South Texas Project Electric Generating Station P.O. Box 289 Wadsworth, Texas 77483

February 22, 2010
U7-C-STP-NRC-100044

South Texas Project
Units 3 and 4
Docket Nos. 52-012 and 52-013
Response to Requests for Additional Information

RAI 04.04-3 Supplement:**QUESTION:**

Figure 6C-2 Core Inlet Delta-P for Blocked and Unblocked Cases

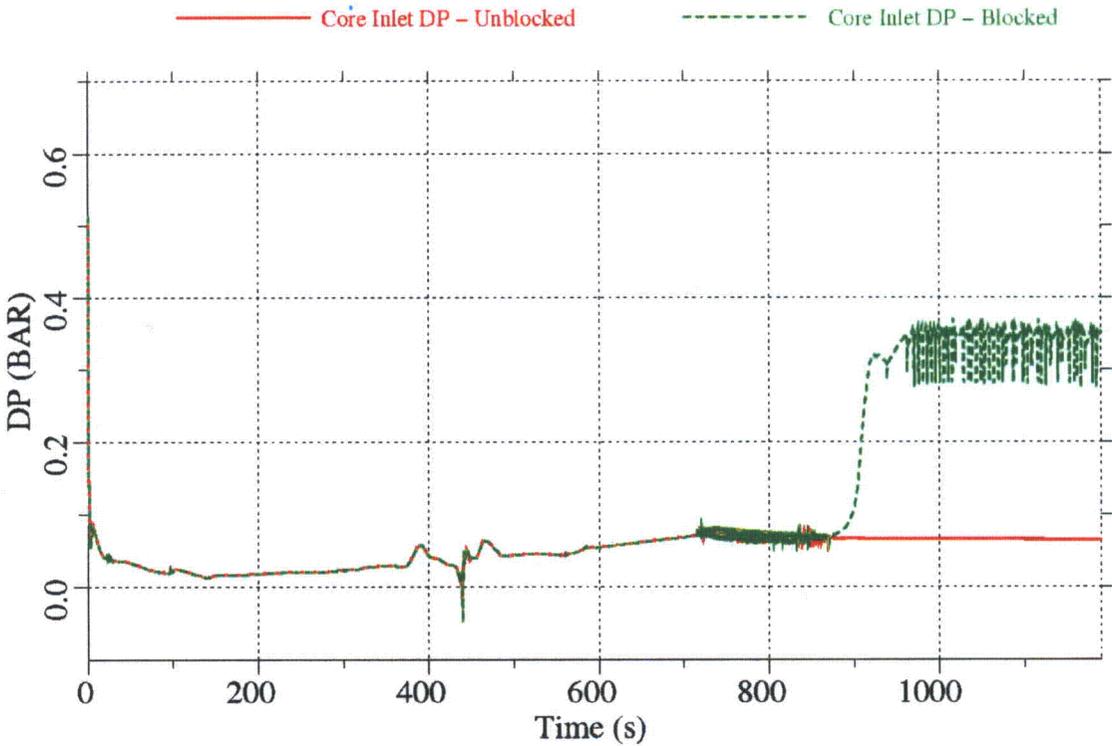
In response to RAI 06.02.02-2, STPNOC in their letter dated Sept 28, 2009 (U7-C-STP-NRC-090141) agreed for a COL license condition to submit an evaluation as part of the license amendment confirming that the fuel for the initial fuel load satisfies the downstream effects of containment debris on the reactor fuel. The acceptance criteria specified in the response are not sufficient.

- a) Provide verifiable criteria for the fuel testing. Revise FSAR Section 4.4 to include the details of the acceptance criteria.
- b) Confirm that the protective coatings debris characteristics for fuel assembly tests will be consistent with the NRC guidance for operating PWRs (NRC Staff Review Guidance Regarding Generic Letter 2004-02 Closure in the Area of Coatings Evaluation, March 2008, ADAMS Accession No. ML080230462.) For example, if a filtering bed is possible on fuel assembly openings, then fine particles representing coatings debris would be included in the debris load. In addition, show how the test requirements will be included in the application (e.g., license condition wording).

Figures 6C-2, 6C-3, and 6C-4 compare the core inlet DP, flow rate and void fractions for the cases with no blockage and with blockage resulting in a reduction of flow area by 90% of inlet flow area. Five minutes is the estimated amount of time required for the debris in the system to start to reach the fuel filters. The models assume clogging begins at 850 seconds because that is when the flow through the core reaches a steady state. In order to ensure that any effects seen are caused by the changes being made, steady flow is required. Despite a very high level of blockage, sufficient flow remains available to the core to ensure that the core void fraction both in the hot assembly and average assembly remain < 0.95 .

The results of the analysis provide an acceptable core inlet differential pressure (DP), corrected for the flow rates to account for the fact that the flow rate will decrease differently in the test loop (supplied by a pump) vs. in the analysis (controlled by natural circulation head).
